C.E. White Seat Mounting Bolt Omitted

BULLETIN

Models Affected: Model Year 2008-10 All American (A3RE) Rear Engine

S 1 0 S E

Figure 1

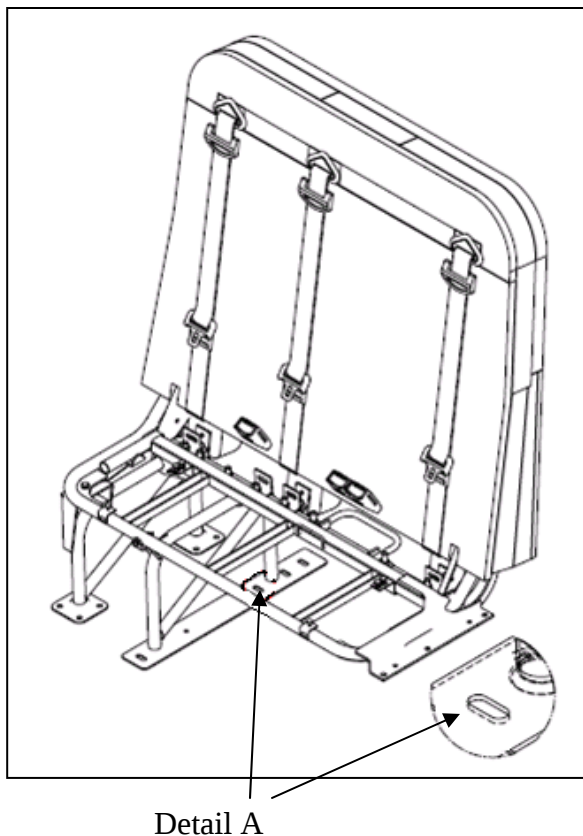
A required mounting bolt may have been omitted in the center leg of the C.E. White Student Safety Seat.

1. Park the vehicle on a level surface, apply parking brake, turn engine off, remove ignition key and chock wheels.
2. Locate the hole in the middle seat leg indicated in figure 1.

Install a 3/8" bolt, washer and nut in the center support leg per instructions below.

3. Drill a 13/32" hole through the floor in the location indicated.
